## COUNCIL ASSESSMENT REPORT

Panel Reference	PPSSNH-298
DA Number	DA-2019/247/A
LGA	Willoughby City Council
Proposed Development	Modification of consent for demolition of existing structures and construction of a new registered club, three seniors living apartment buildings containing self-contained dwellings, a residential aged care facility, shop top housing, basement carparking and ancillary uses including a new park
Street Address	26 Crabbes Avenue, Willoughby NSW 2068 and 243, 247 to 255 Penshurst Street, Willoughby NSW 2068
Applicant/Owner	Applicant: Hycorp Property Group Owners: Willoughby Legion Ex-Services Club Ltd (26 Crabbes Avenue) Dants Pty Ltd (247-255 Penshurst Street)
Date of DA lodgement	8 February 2022
Number of Submissions	Six (6) objections
Recommendation	Approval
Regional Development Criteria (Schedule 7 of the SEPP (State and Regional Development) 2011	S4.55(2) development standard exceeded by more than 10% (8m building height standard under Seniors SEPP)

**SNPP NO:** PPSSNH-298  
**COUNCIL:** WILLOUGHBY CITY COUNCIL  
**ADDRESS:** 26 Crabbes Avenue & 243, 247 - 255 Penshurst Street  
NORTH WILLOUGHBY NSW 2068.  
**DA NO:** DA-2019/247/A  
**PROPOSAL:** MODI

Figure 4: Figure 14 is displayed within the Site Compatibility Certificate Application Report, prepared by City Plan Services for the purposes of obtaining a SCC from the Department.

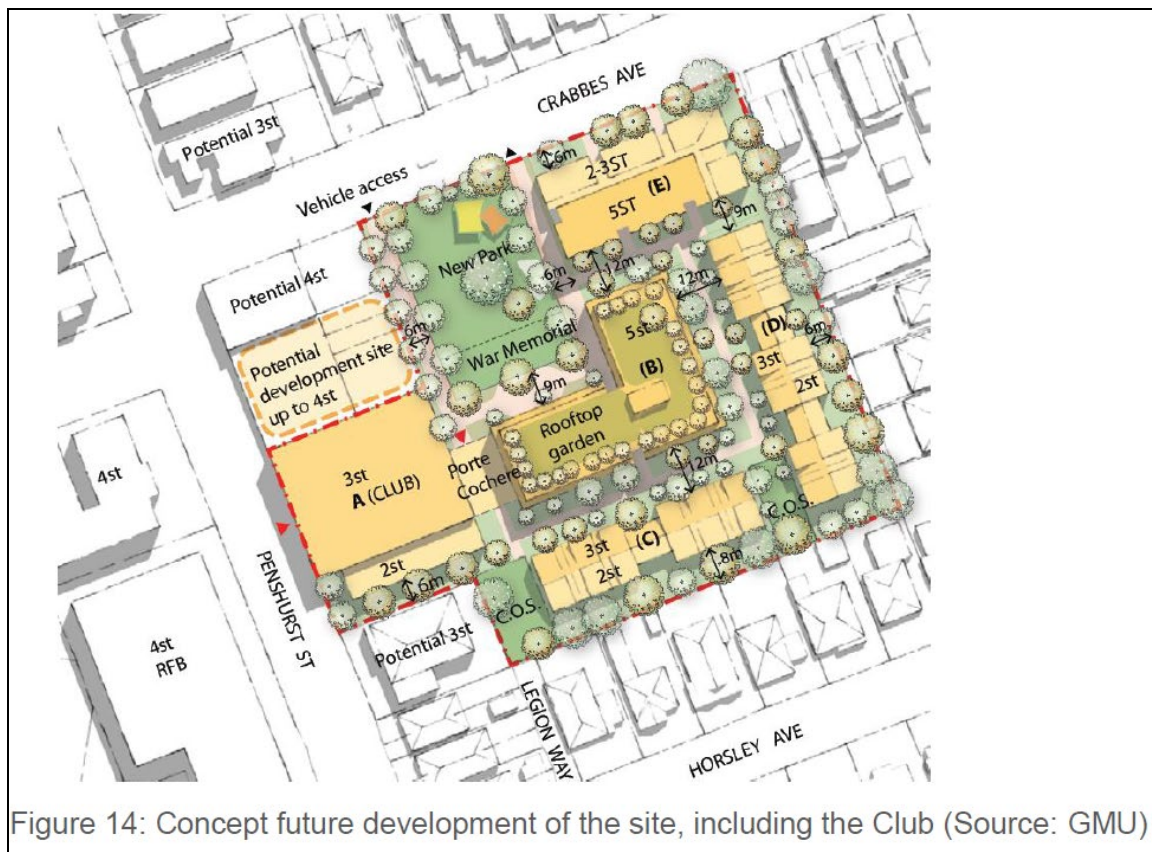
The proposed development meets all setback requirements from boundaries, and generally satisfies the setbacks between buildings, noting there is slight variation between buildings A and C from Building C (refer Figure 1 in this report).

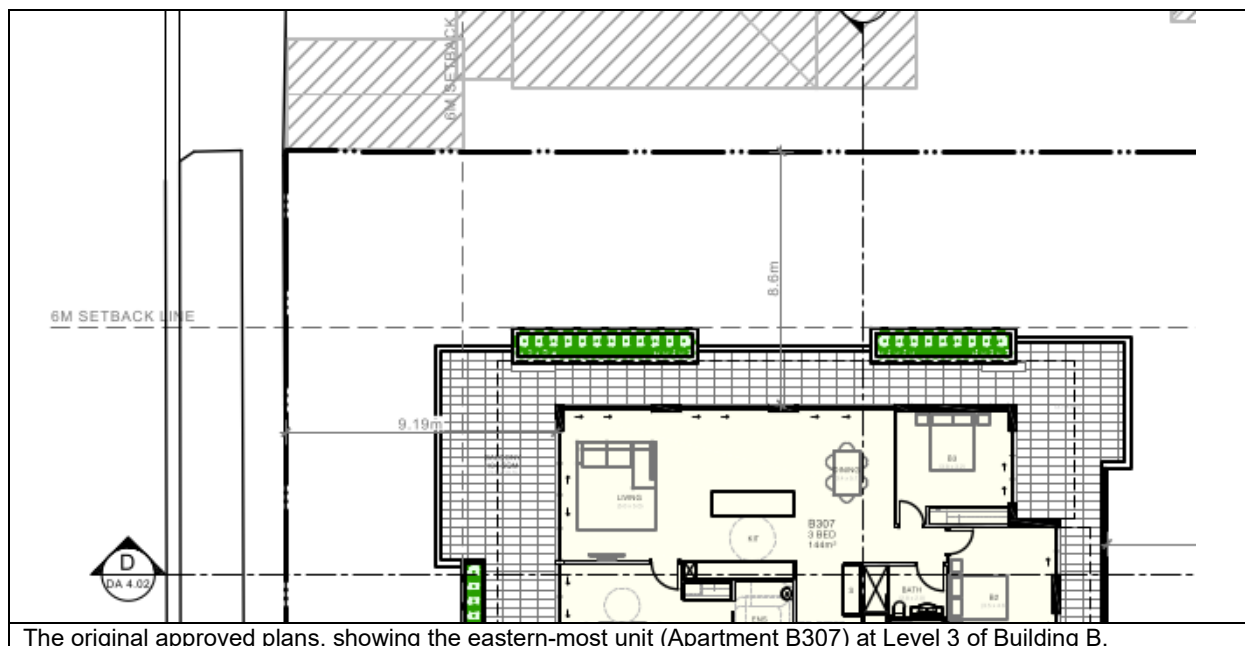
Building B was approved with an RL 105.00 at the ceiling. This increases to RL 105.50 in this application, which equates to a height of 9.9m using an existing ground level of RL 95.6. the ground level is interpolated using three levels (RL 95.72, RL 95.18 and RL 95.97). The building height exceeds the Seniors SEPP standard of 8m by 1.9m or 23.75%.

Whilst there is no specific height objective under the Seniors SEPP, case law provides that the underlying purpose of the standard is to provide a development that will be compatible with the adjoining residential area and not create adverse impacts having regard to the desirable elements of the location and character of the area. Further, that the Urban Design guidelines for infill development are relevant in determining the underlying objectives of the cl40(4) of the Seniors SEPP and that the relevant objectives are to minimise impacts to privacy and amenity of existing neighbouring dwellings, minimise overshadowing, retain views

and outlook to existing mature planting, reduce the apparent bulk of development on neighbouring properties, and provide adequate building separation.

The modified proposal retains the same number of storeys as required by the SCC. The proposal steps down in its massing at the neighbouring property boundary at the east in response to the adjoining lower density residential zone. Also, the building separation has been retained at 8.6m which offers sufficient building separation to minimise visual impacts. Also, window sizes have been reduced in the elevation facing the neighbouring properties to the east (units B107 and B207).

The original approved plans, showing the eastern-most unit (Apartment B307) at Level 3 of Building B.

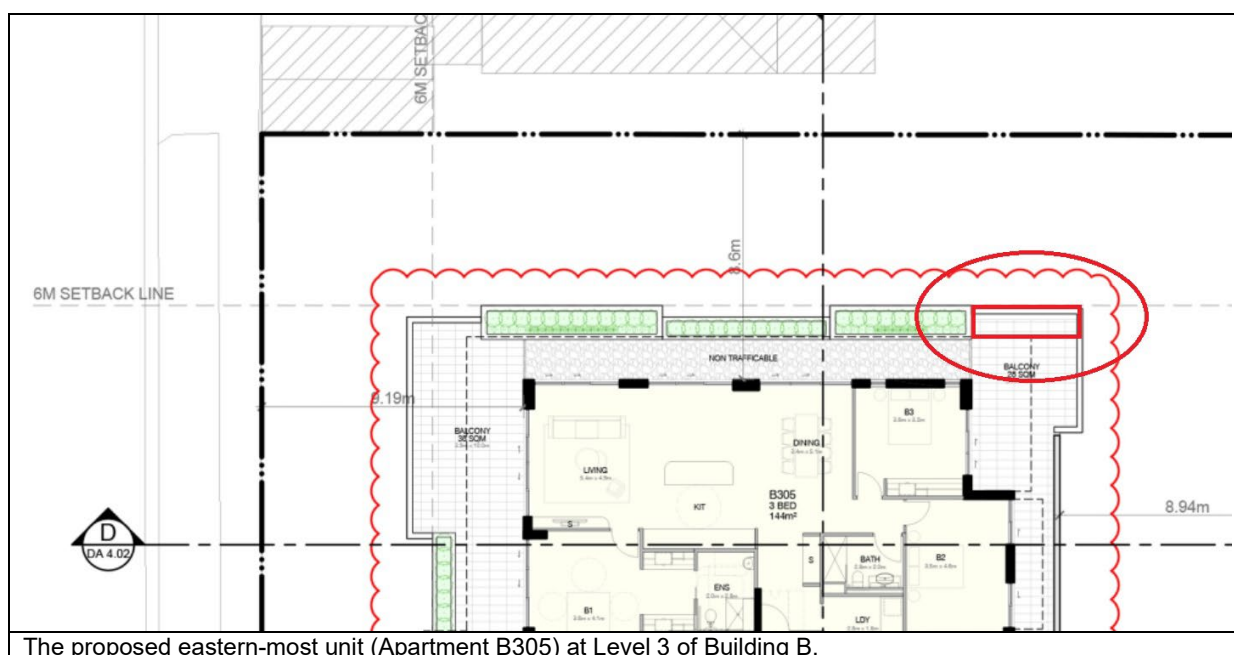
Apartment B307 is deleted and replaced with B305 in the subject application, which occurs with the arrangement of this floor with the loss of 2 apartments from level 3 (Plan 5) of Building B. The approved drawing shows as follows:

A non-trafficable roof is now proposed as shown, except that there are portions of the balcony that are located eastwards of the eastern façade of the apartment. To ensure that privacy is suitably protected to the adjoining properties a planter bed is required to be incorporated into the eastern edge of the balcony in the location outlined and circled in red.

- (c) The balcony to Apartment B307 B305 within Building B shall be modified by ~~deleting the portion of the balcony eastwards of the eastern façade of the apartment i.e. the balcony should not extend beyond the eastern façade of the apartment;~~ incorporating a minimum 1m wide and 1m deep landscape bed into

the eastern edge of the balcony of unit B305 that serves Bedroom 3, incorporating planting that grows to a height of at least 0.5m;

**Figure 5: Screen detail on the eastern elevation of the RACF**

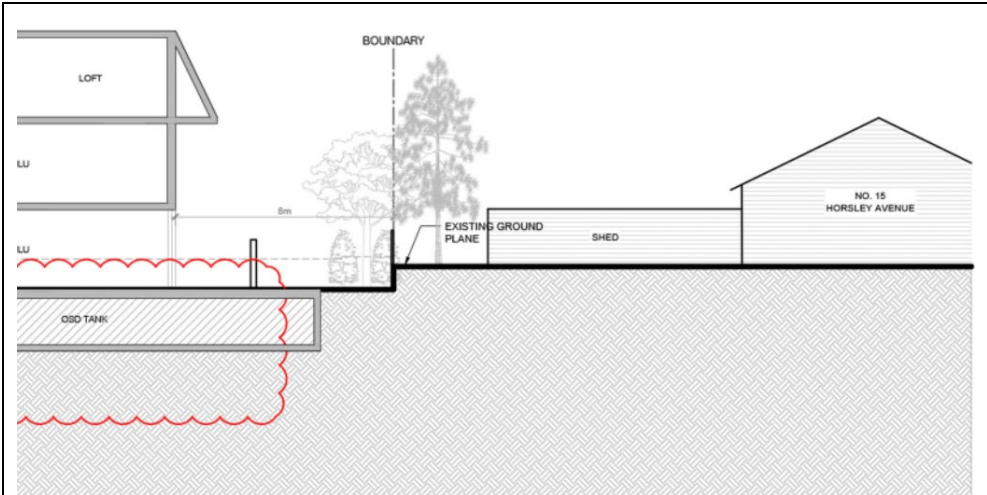
Loss of privacy to 23 Horsley Avenue	The east elevation of the RACF faces the rear yards of properties on Horsley Avenue. The drawings show screens on the upper east-facing windows. Further details have been provided by the applicant which shows an aluminium privacy screen with "medium" spacing of horizontal members at its lower portion, "narrow" spacing at the mid-section and "medium" spacing at the upper portion. The privacy screen, in conjunction with the separation of the building, is considered to satisfactorily reduce privacy to properties on Horsley Avenue.

- (g) The privacy screen detail shown on Drawing DA402 Rev 1, plot dated 20/05/2022 prepared by Hyecorp must be used for all windows at the upper southern elevation of the Residential Aged Care Facility (RACF) to ensure adequate privacy protection for residents along Horsley Avenue, and to east-facing windows of the RACF at Levels 2 and 3 to ensure privacy protection between the RACF and Building C.
